23rd September, 2022

To: NSW Planning – Inland Rail - Narromine to Narrabri SSI-9487 Response

Figure 3 Topography and drainage patterns of prospective irrigated area

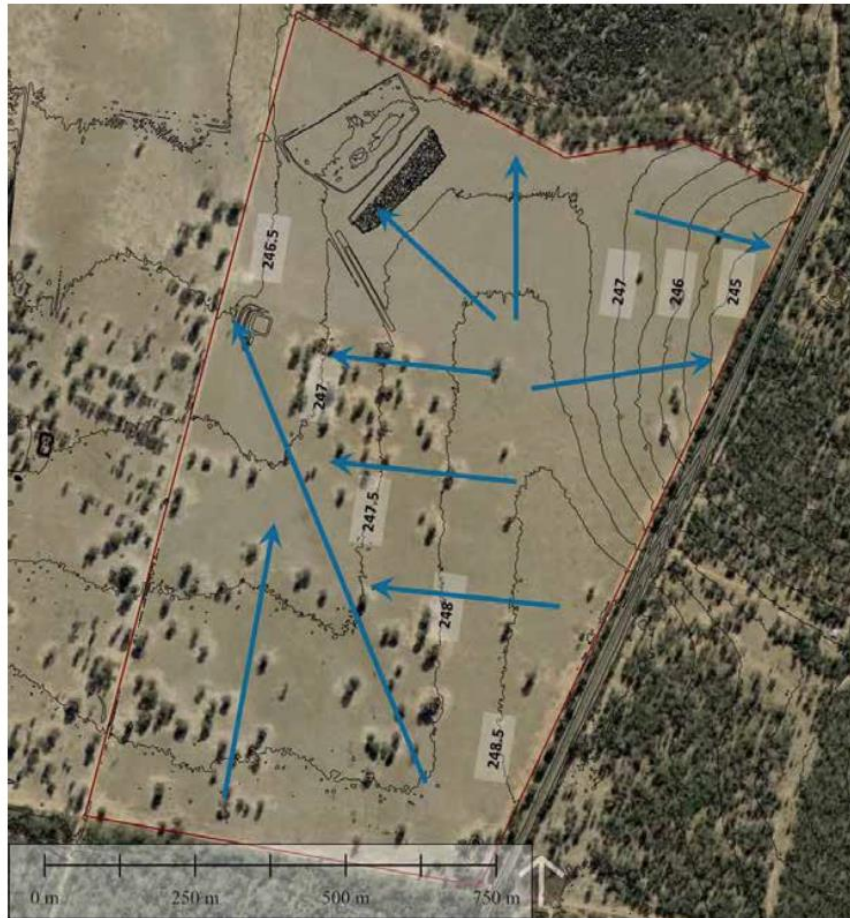
The image below shows the drainage channel that traverses the Leewood facility diagonally from the south-west corner to north-west. It flows through the area where Santos wish to build their gas-processing facility, crystalliser and managed released infrastructure (Narrabri Gas Project EIS).

Has the risk of the ponds overflowing or failing been considered with the design of the alignment and culvert system?

Has the ARTC consulted with Santos about the possibility that the alignment of the track on the northern side of the Leewood facility could potentially impact the facility negatively by holding back this flow of drainage?

APPENDIX E - Map 67 of 148

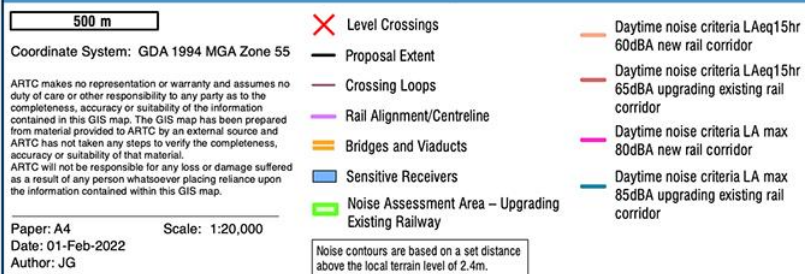
Whilst Santos have stated that they planned to minimise impacts from their infrastructure by placing major facilities such as Leewood outside of the main forested body of the Pilliga the addition of the Inland Rail increases exponentially the cumulative impact of the Leewood facility. In short, the Inland Rail, by running congruent to Leewood is increasing impacts and could lead to the sustained inundation of the remnant vegetation on Leewood by surface water run-off.
